## **AX PRO**

# Version: V1.2.9

**Release Note**

## (2024-04-15)

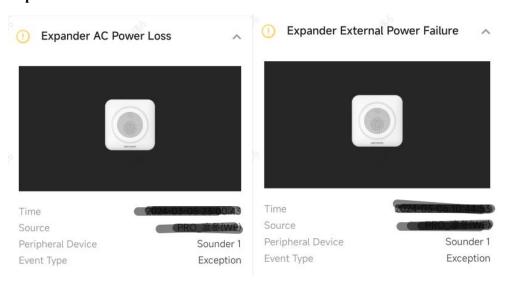
Modify authorization permissions, default arm and disarm/Silence alarm

permissions aren't granted to HPP (installer), but still support HC (end user) to manually tick. Permissions remain unchanged in the rest of the cases.

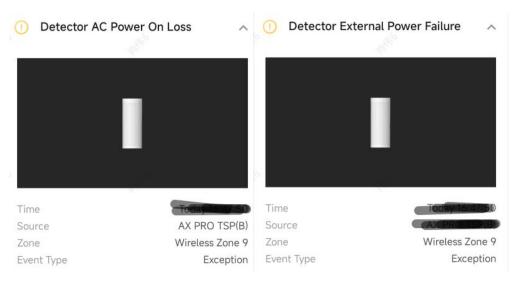
Detector's original AC Power Loss notification modified to Detector External Power Failure.
